Re: Cien Aguas Charter School 2501 Buena Vista Dr SE Traffic Circulation Layout Engineer's Stamp 10-25-2021 (M15-D004B)

The TCL submittal received 11-03-2021 is approved for Building Permit with. A copy of the stamped and signed plan will be needed for each of the building permit plans. Please keep the original to be used for certification of the site for final C.O. for Transportation.

Cien Aguas Charter School 2501 Buena Vista Dr SE Albuquerque, NM 87106 Plan Site

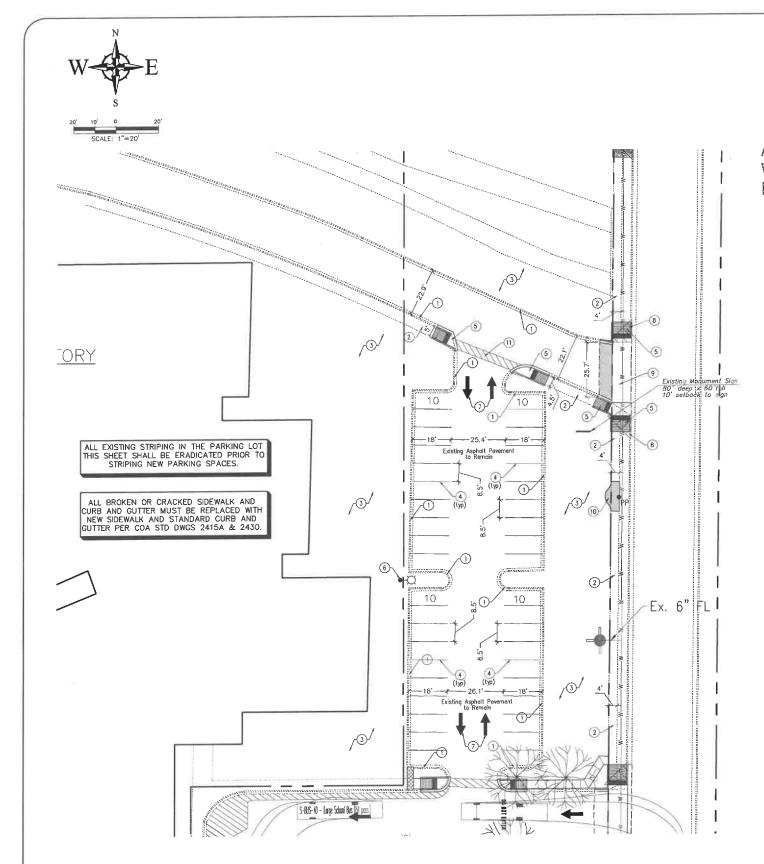
CONDITION OF FINAL C.O. APPROVAL: BUBBLED OUTS ON SIDEWALK TRUCTION OBSTRUCTION BUSIN VISTA-FRONTAGE); BE AFPROVED RELOADED
